WCAP-14577 Rev. 1-A
Project Number 686

Subject: Westinghouse Owners Group
**Transmittal of Approved Version of WOG Aging Management Report,
"License Renewal Evaluation: Aging Management for Reactor Internals",
WCAP-14577 Rev. 1-A (MUHP-6110)**

WCAP - 14577
Rev. 1-A

Figure 4-1 Reactor Internals License Renewal Fatigue Evaluation

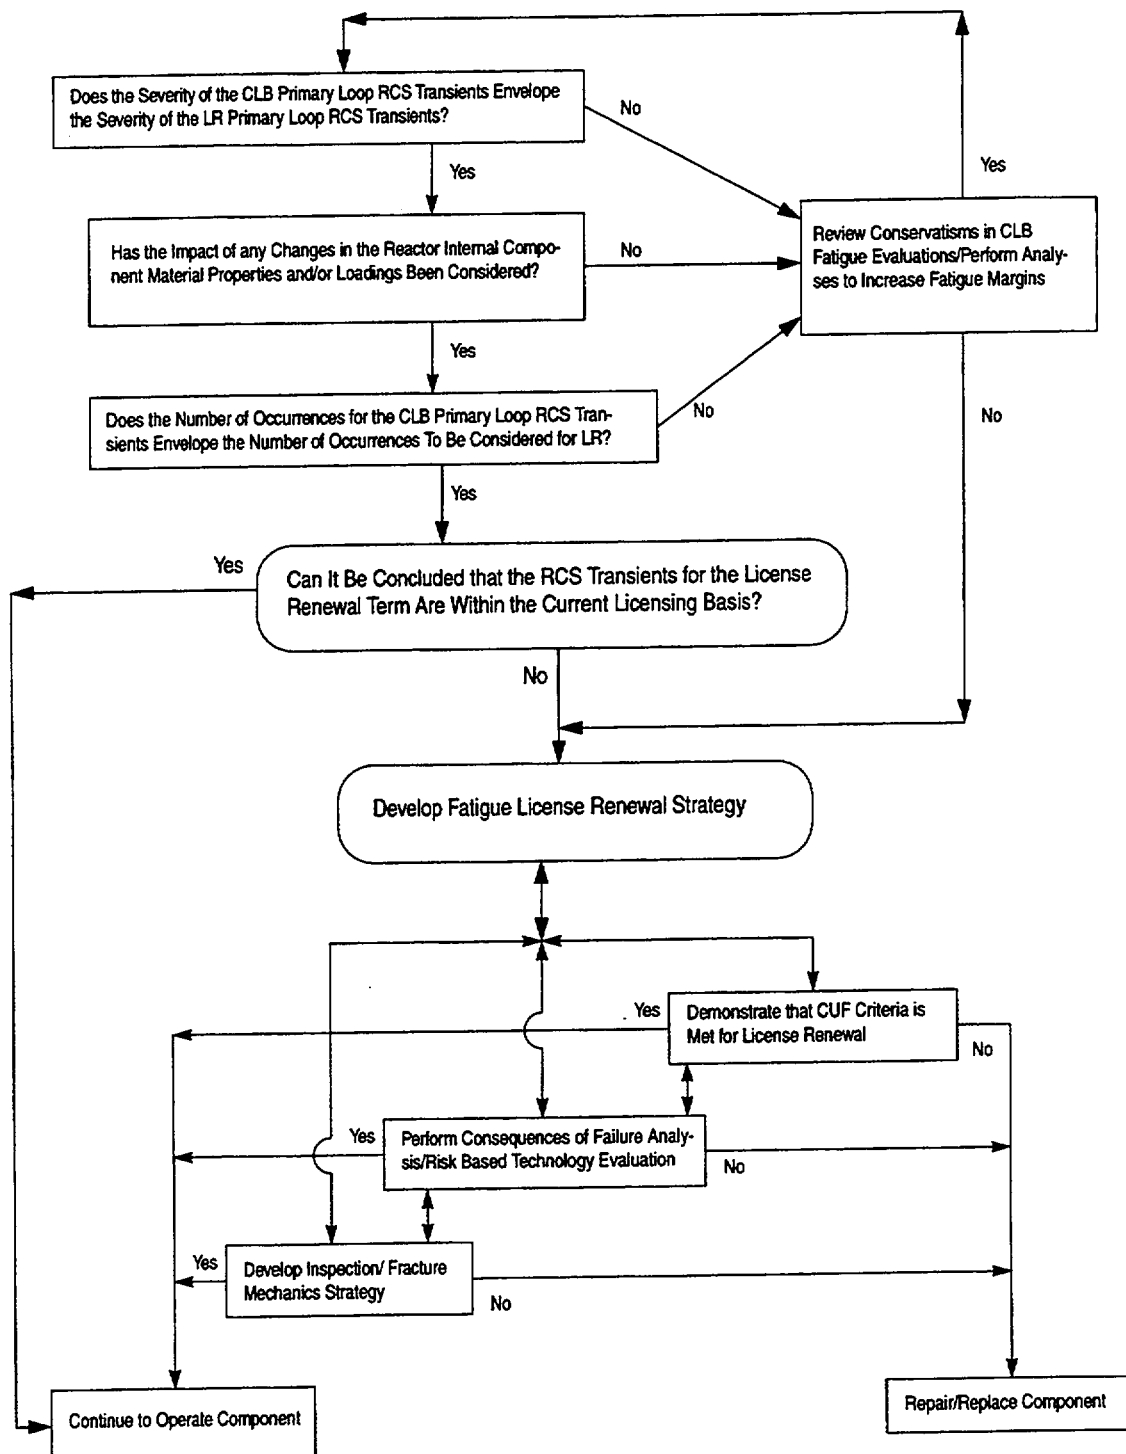
The license renewal application will follow the flowchart in Figure 4-1 of WCAP-14577 to assess the acceptability of the RVI components relative to fatigue for the extended period of operation.

The preferred approach, shown in the first part of Figure 4-1, is to demonstrate that the fatigue effects anticipated for the license renewal term are bounded by the fatigue effects anticipated for the original service period. This includes an assessment of the number and severity of the RCS design transients anticipated during the extended period of operation relative to those assumed to occur in the Current Licensing Basis (CLB), and an assessment of the impact of changes to the reactor internal component material properties that may have occurred during the current licensing period.
